CITY OF DULUTH
Planning Division

STAFF REPORT

File Number	PL 14-011		**Contact**	Jenn Reed Moses, jmoses@duluthmn.gov	
Application Type	Planning Review		**Planning Commission Date**	March 11, 2014	
Deadline for Action	**Application Date**	February 10, 2014	**60 Days**	April 11, 2014	
	Date Extension Letter Mailed	February 20, 2014	**120 Days**	June 10, 2014	
Location of Subject	1720 Miller Trunk Highway				
Applicant	Bob Sullivan		**Contact**	218-828-0629, bsully@brainerd.net	
Agent	Bill Scalzo		**Contact**	218-722-4319, wscalzo@scalzoarchitects.com	
Legal Description	010-2585-00015				
Site Visit Date	February 27, 2014		**Sign Notice Date**	February 25, 2014	
Neighbor Letter Date	February 24, 2014		**Number of Letters Sent**	15

PL 14-011
MU-C Plan Review
1720 Miller Trunk Hwy

1 A0.0 **SITE PLAN** 1"=20'-0"

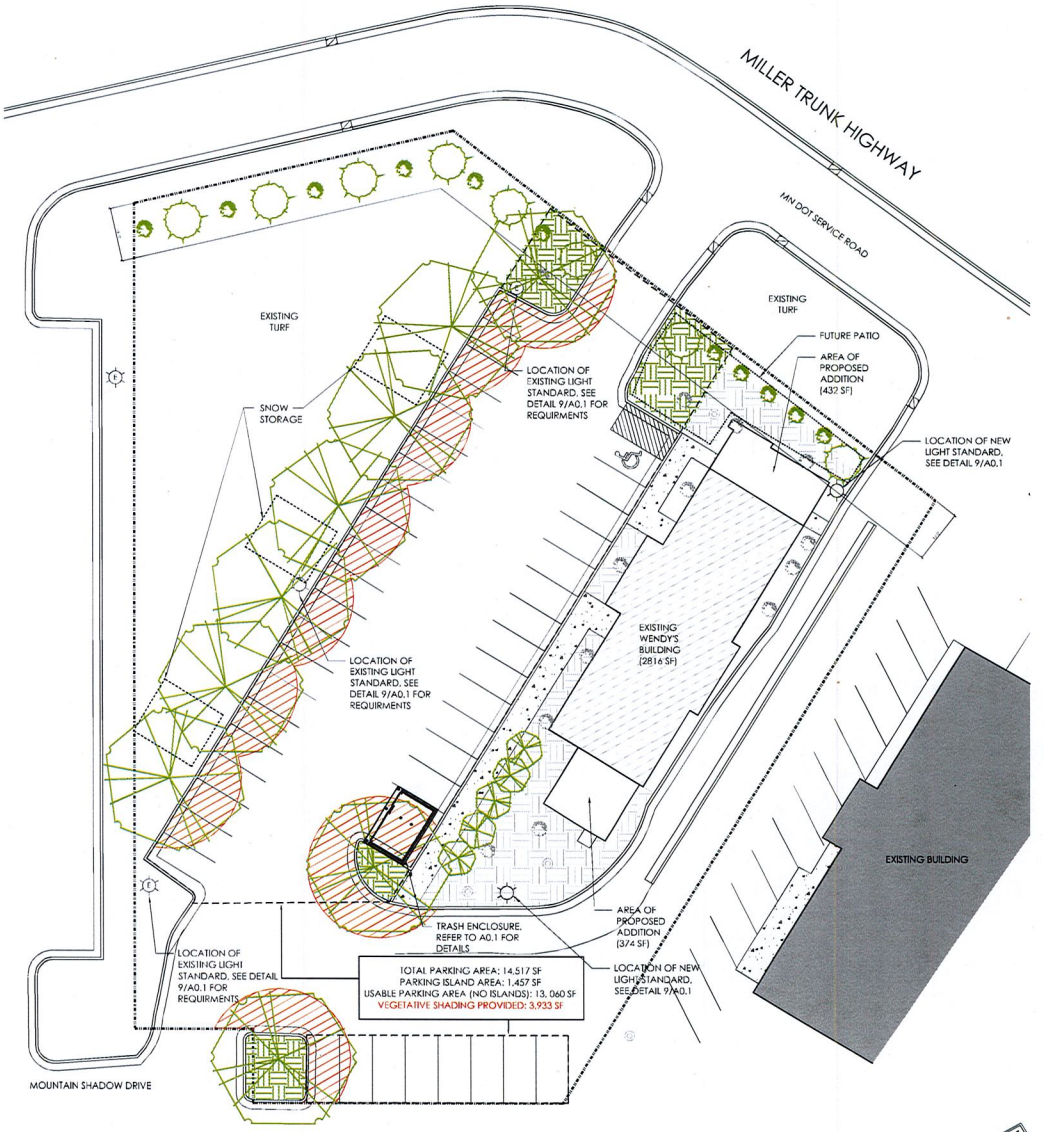
3.) 50-23 - Project is improving accessibility by adding a handicapped aisle in the parking lot.
4.) 50-24 - Existing parking lot contains 42 spaces; under the proposed site plan, one space would be removed, for a total of 41 spaces. The maximum allowed amount of parking for a 3,622 square foot building (including the two additions) is 27 spaces; however, per UDC Section 50-24.4, existing paved parking lots are allowed to remain unless the parking lot is reconstructed. Note that other than landscaping (see below), no changes will be made to the parking lots.

5.) 50-25 - Because the value of the project triggers the applicability threshold in Section 50-25.1, applicant proposes to provide street frontage landscaping and parking lot landscaping (10% landscaped islands and 30% tree canopy coverage). Snow storage is shown on the site plan.

6.) 50-26 - Dumpster is currently located over an existing utility easement. Applicant proposes to move dumpster and provide an enclosure. No fences, loading docks, or ground-mounted mechanical equipment are proposed. Any roof-mounted mechanical equipment will be screened as required by the UDC.

1.) The project be limited to, constructed, and maintained according to the Site Plan dated February 14, 2014, and received by the Planning Division March 4, 2014.

Miller Trunk HWY Duluth, MN
LED Lighting Analysis

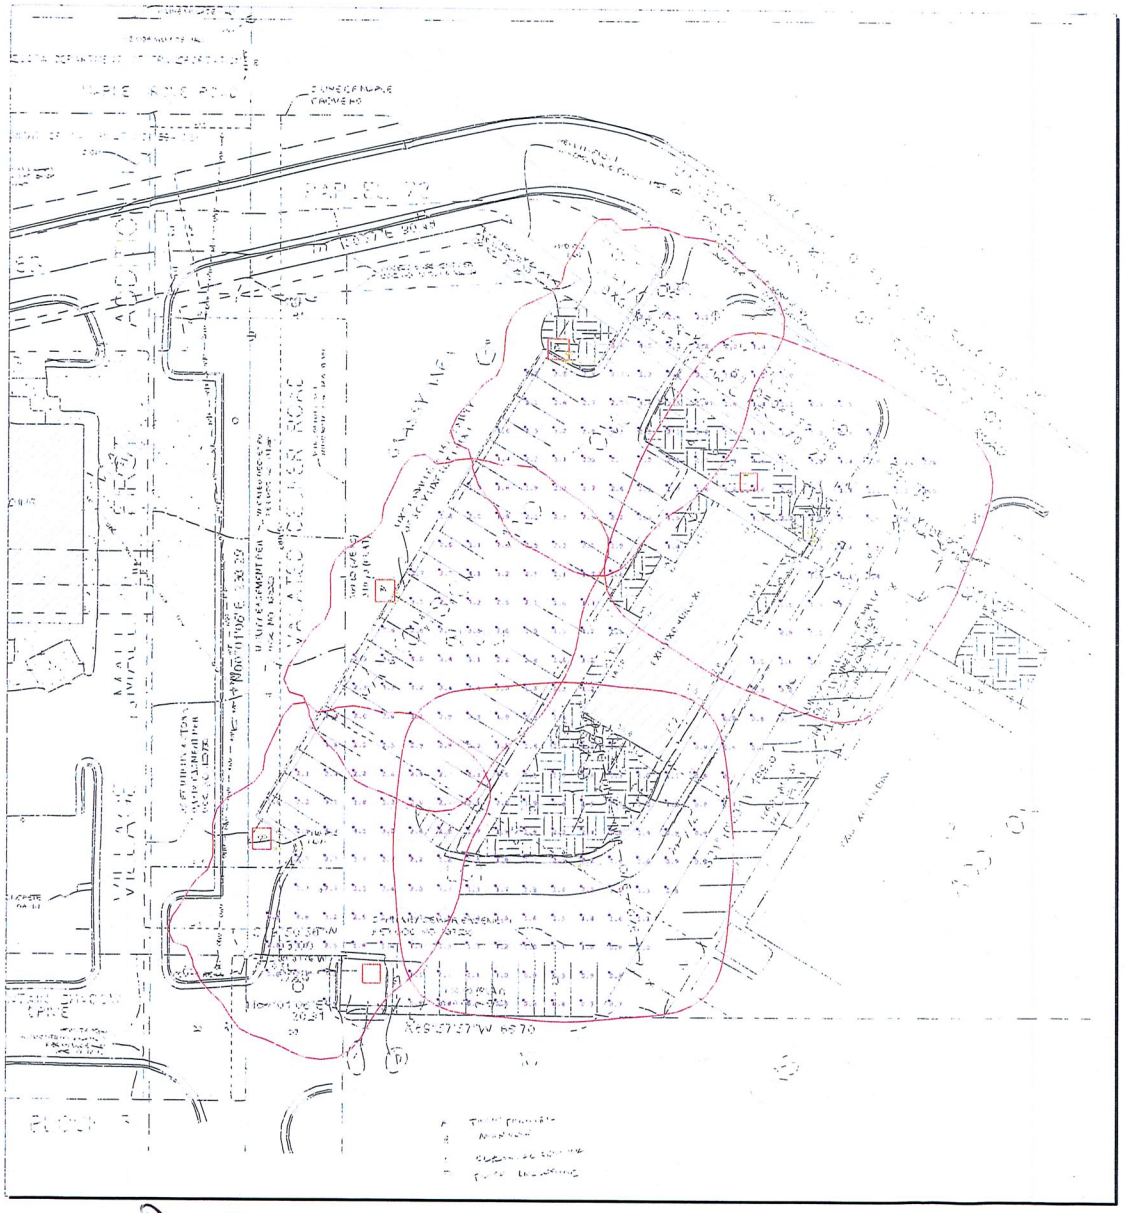
9.) 50-31 - Photometric plan meets UDC requirements for maximum lighting. Lighting will meet UDC requirements for cut-off fixtures, pole height, etc.
10.) No public, agency, or City comments were received.
